Access Compliance Report

Public Rights-of-Way

(Curb Ramps)

Intersection ID: 9073	Main Street: HUNTERS_CROSSING_LN	Cross Street: THE_PLAZA	Location:	N
ADA ID: CD80335862FD	Ramp Type: PerpDiag	Initial Pass/Fail: Fail	Overall Compliance: No	Severity Score: 8.75
Codes/Mitigation Info/Possible Solution		Field Measurements/Component Compliance

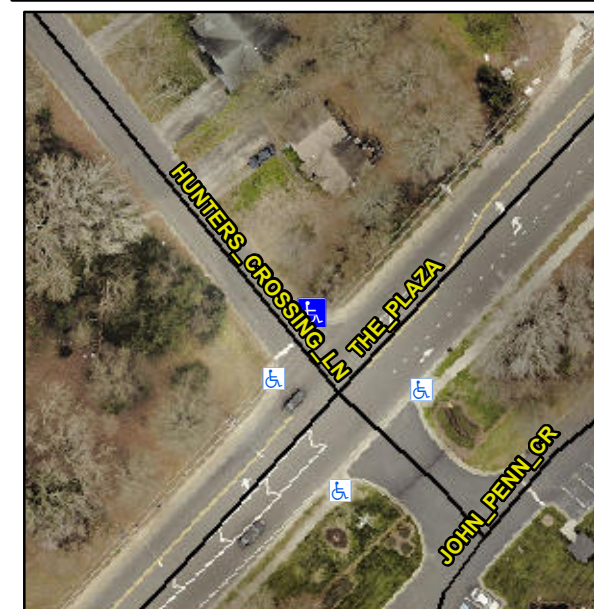
Not Found, R304.5.1

Compliance	Description	Data	Compliance	Description	Data
N/A	Ramp Length (in)	61.5	Yes	Ramp Slope (%)	6.5
No	Ramp Width (in)	46.0	Yes	Ramp XSlope (%)	1.4
N/A	Flare Type LT	N/A	N/A	Flare Type RT	N/A
N/A	Flare Slope LT (%)	N/A	N/A	Flare Slope RT (%)	N/A
N/A	Flare Traversable LT?	N/A	N/A	Flare Traversable RT?	N/A
N/A	Landing Length (in)	N/A	N/A	DWS Provided?	N/A
N/A	Landing Width (in)	N/A	N/A	DWS Contrast?	N/A
N/A	Landing Slope (%)	N/A	N/A	DWS Length (in)	N/A
N/A	Landing X Slope (%)	N/A	N/A	DWS Full Width?	N/A
N/A	Landing Curb? (Y/N)	N/A	N/A	DWS Offset (in)	N/A
N/A	Shared Landing?	N/A			
N/A	Gutter Ponding?	Yes	N/A	Gutter Slope (%)	N/A
N/A	Gutter Lip Ht (in)	N/A	N/A	Gutter X Slope (%)	N/A
N/A	Painted X Walk1?	No	N/A	Painted X Walk2?	No
	X Walk 1 Direction	To SW		X Walk 2 Direction	To SE
N/A	X Walk 1 Width (in)	N/A	N/A	X Walk 2 Width (in)	N/A
	X Walk 1 Slope (%)	0.8		X Walk 2 Slope (%)	2.2
	X Walk 1 X Slope (%)	0.4		X Walk 2 X Slope (%)	2.5

Remove & Replace Curb Ramp With Two New Directional Ramps or Equivalent.
